TRUCK, UTILITY, L/W, MC2, FFR, LAND ROVER 110

PREPARATION OF RIGHT HAND BRACKET AND BUMPER ASSEMBLY, JERRICAN HOLDER, FOR FITTING OF MAST ANTENNA GENERAL PURPOSE AB-F300

MODIFICATION INSTRUCTION

Figure 1 Position of Holes

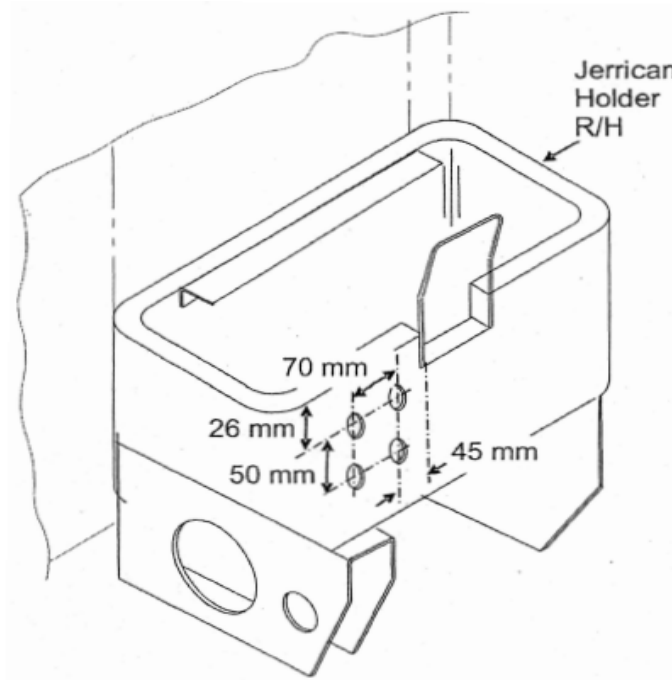
9. **Modification of Jerrican Holder Right Hand.** The procedure is as follows:
- mark and centre punch the four (4) holes (to be drilled), as detailed in Figure 1;
 - drill four (4) holes using 11 mm drill bit; and
 - de-burr the holes.
